REQUEST FOR PROPOSAL

Addendum # 2

RFP Title: **On-Board Systems / Communication Center System**

RFP Number: **04-001PR**

ATTACHMENT ONE: Aerial photograph of Bellevue base for insertion as new Page 13 of Appendix B. See Question 37 above.

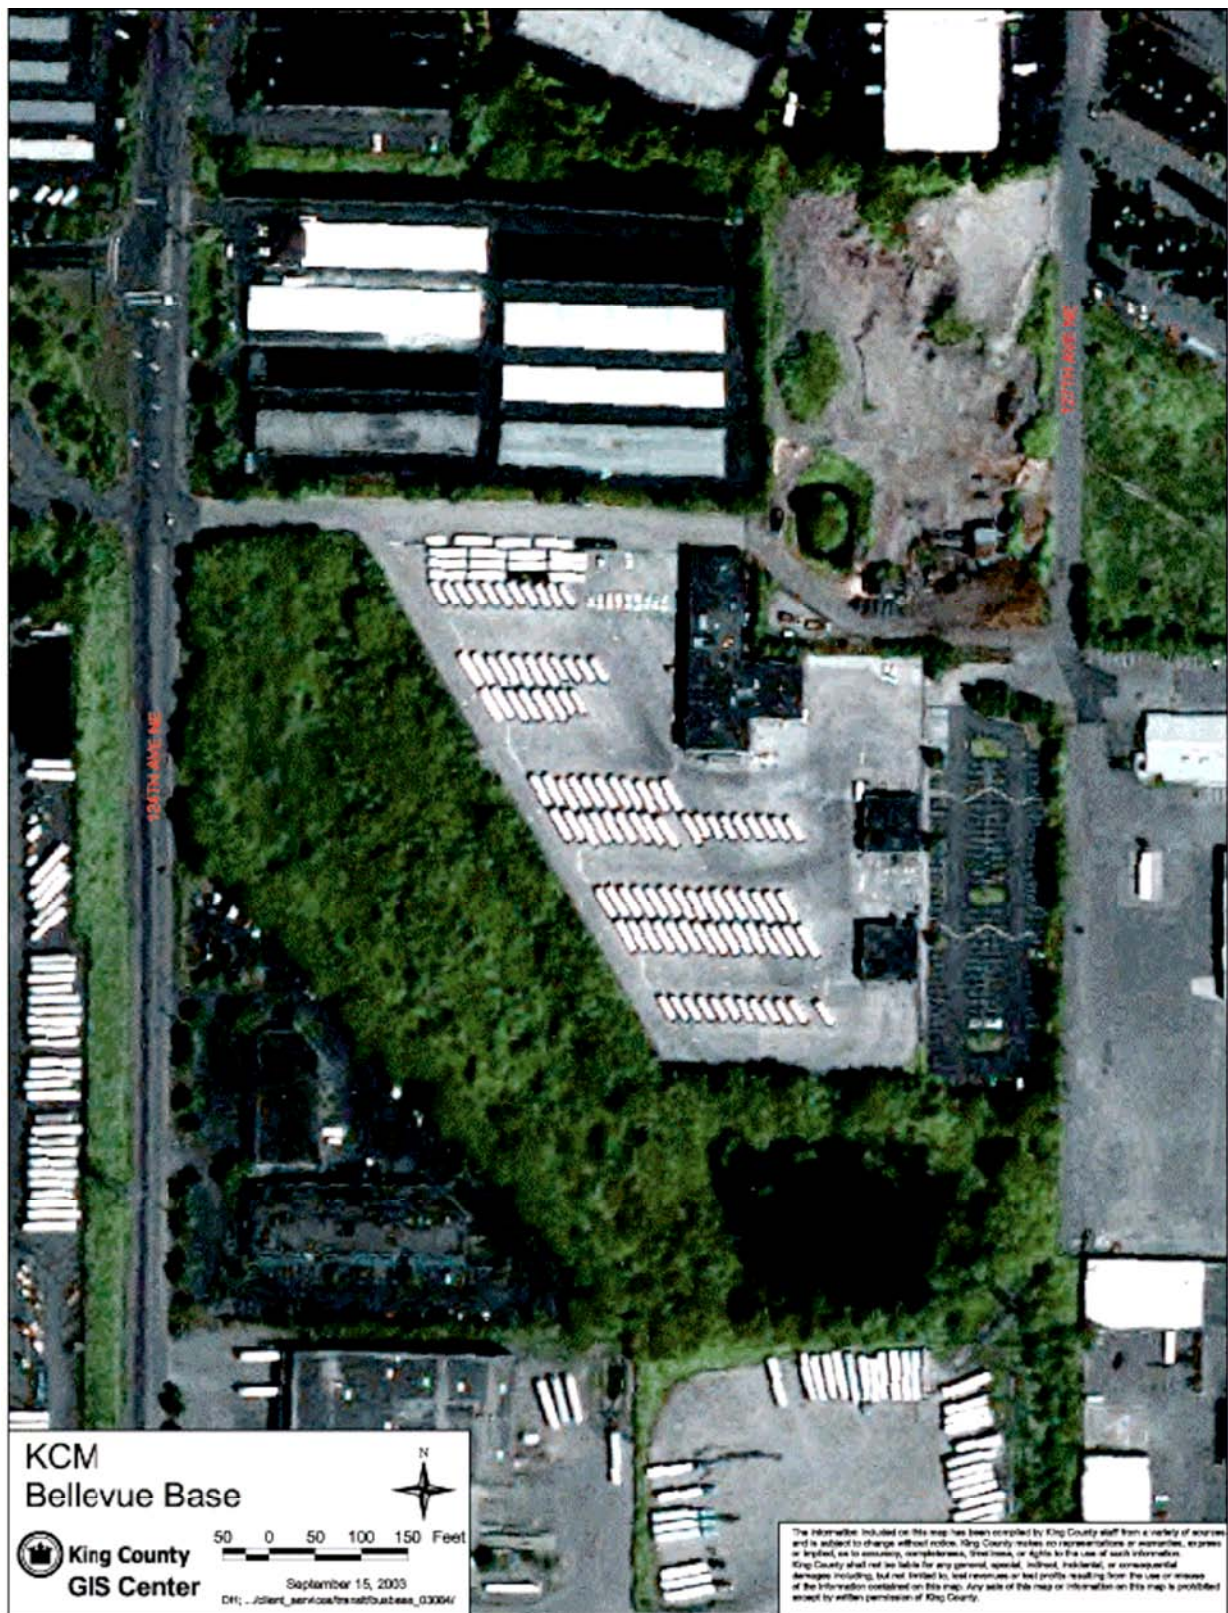
37.			ADD: new Page 13 containing aerial photograph of Bellevue base. (See Attachment One for new aerial photograph of Bellevue base.)
Part C, Appendix D Security Camera Interface [now DVRS Interface]
